Mobile Intel® Celeron® Processor on 0.13 Micron Process in Micro-FCPGA Package

Specification Update

February 2007

Document Number: 251309-029

Figure 12. System Bus Reset and Configuration Timings

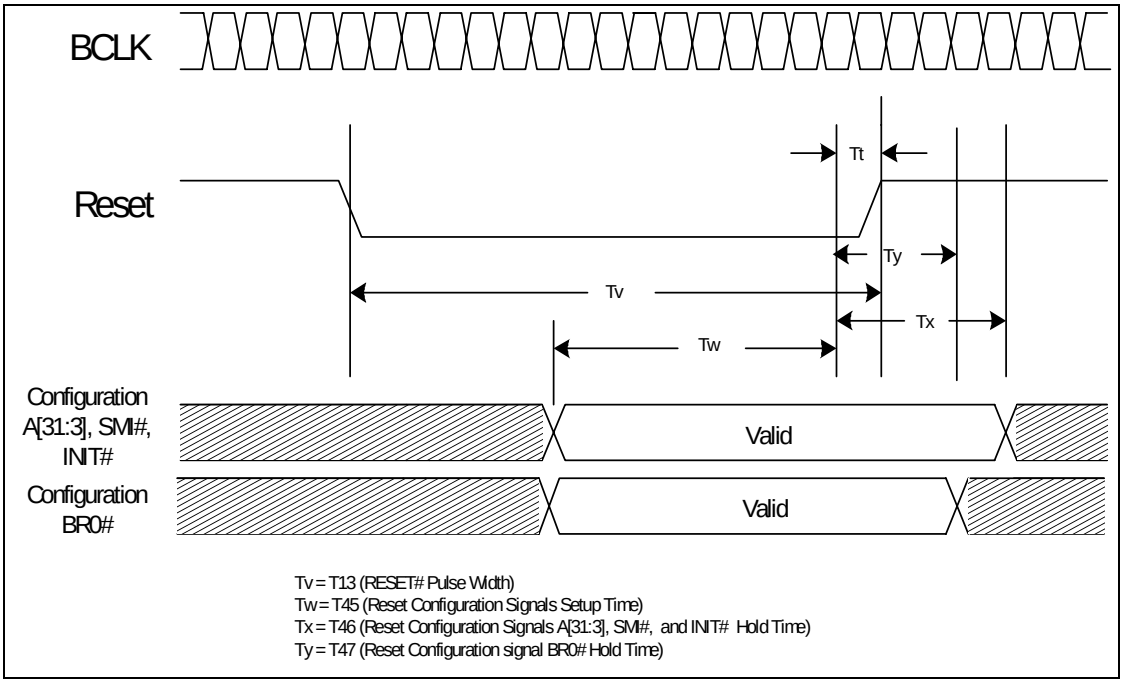
V2. BR0# Maximum Hold Time Specification Change

The BR0# maximum hold time has changed to 2 BCLKs. This change will be shown in the "System Bus AC Specifications (Reset Conditions)" table and "System Bus Reset and Configuration Timings" figure of the *Mobile Intel® Celeron® Processor on .13 Micron Process in Micro-FCPGA Package Datasheet.* This change will be incorporated in the next revision of the datasheet.

The following figure will be modified to reflect this change:

T# Parameter	Min	Max	Unit	Figure	Notes
T45: Reset Configuration Signals (A[31:3]#, BR0# INIT#, SMI#) Setup Time	4		BCLKs	13	1
T46:Reset Configuration Signals (A[31:3]#,INIT#, SMI#) Hold Time	2	20	BCLKs	13	2
T47: Reset Configuration Signal BR0# Hold Time	2	2	BCLKs	13	2
